# REGIONAL REVIEW NOTIFICATION

**TO:** Mayor Rochelle Robinson, City of Douglasville  
**ATTN TO:** Ryan Anderson, Zoning Administrator, City of Douglasville  
**FROM:** Douglas R. Hooker, ARC Executive Director  
**RE:** Review of Douglas County Graduation, Multipurpose Arena DRI 3523

**DOUGLAS COUNTY GRADUATION – MULTIPURPOSE ARENA DRI**  
**City of Douglasville**  
**Natural Resources Group Review Comments**  
**January 24, 2022**

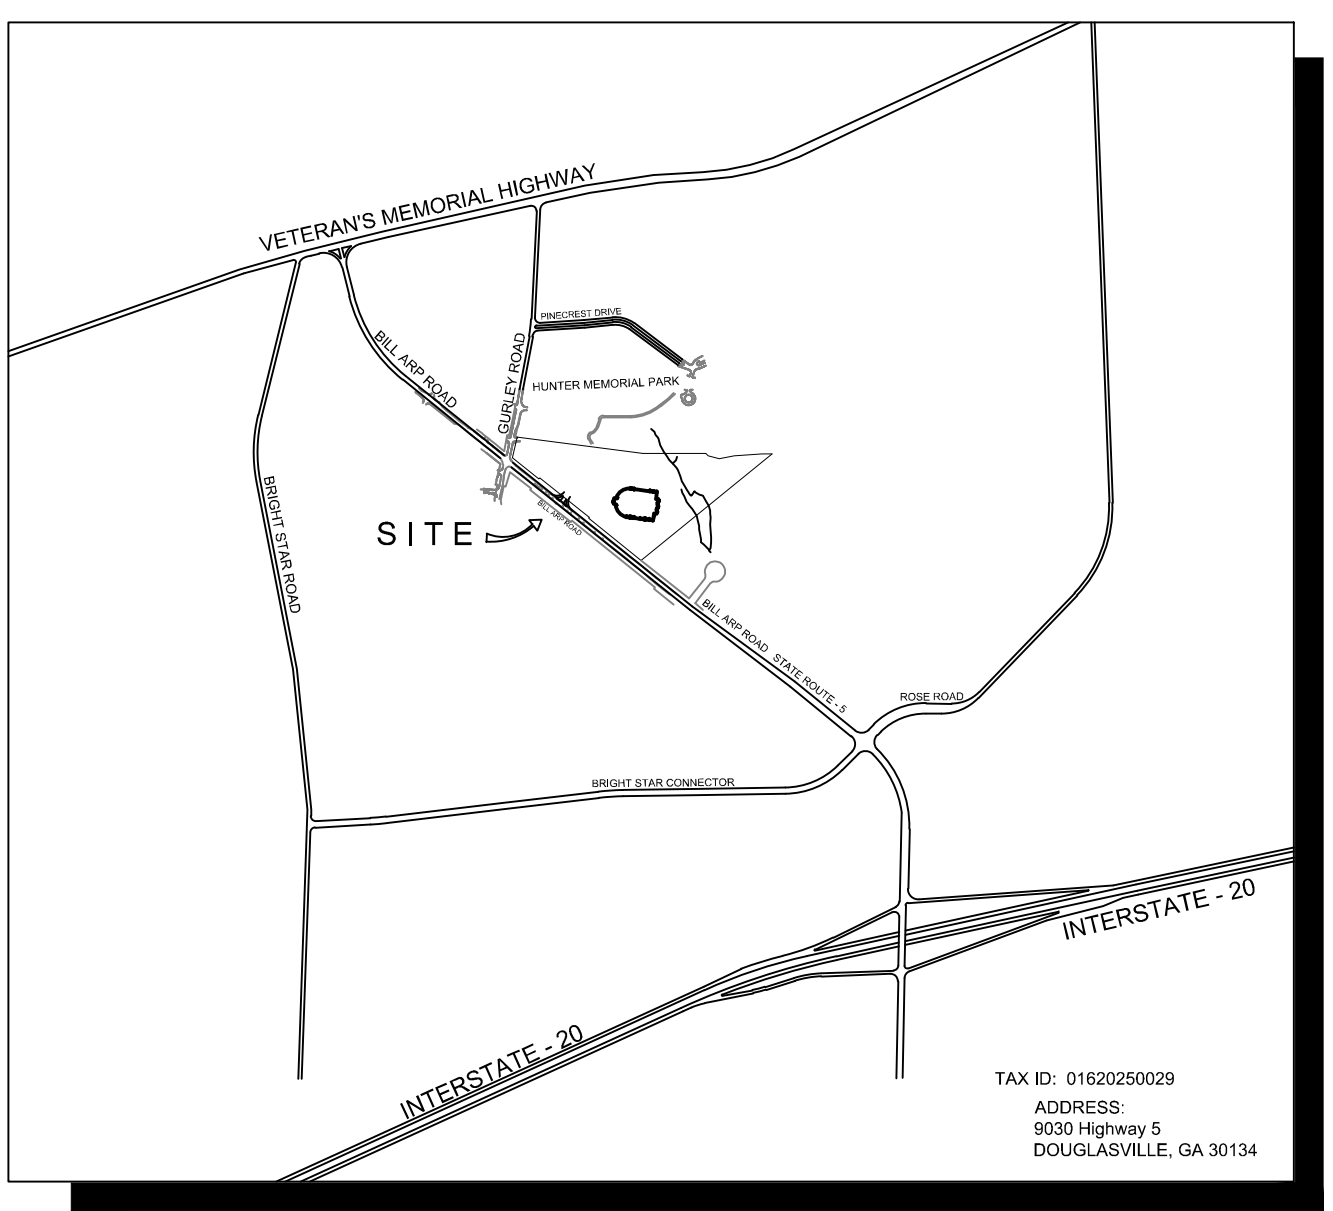
Both the USGS coverage for the project area and the project site plan show a blue line tributary to Anneewakee Creek on the eastern end of the proposed project site. The submitted site plan also shows a tributary to that stream at the southern end of the project site. The site plan shows buffers on both streams. Although not specifically identified, they appear to be 50-foot undisturbed stream buffer and additional 25-foot impervious setback required under the City's Stream Buffer Ordinance (and the Anneewakee Watershed Ordinance) as well as the State 25-foot State Erosion and Sedimentation Control buffer. Intrusions into the City buffers are shown on both streams for grading and parking. These intrusions may require variances under the both the City Stream Buffer Ordinance. Any intrusions into the 25-foot buffer may require variances from and the State 25-foot State Erosion and Sedimentation Control buffer. Any unmapped streams on the property may also be subject to the City buffer ordinance. Any unmapped State waters identified on the property may also be subject to the State 25-foot Sediment and Erosion Control buffer.
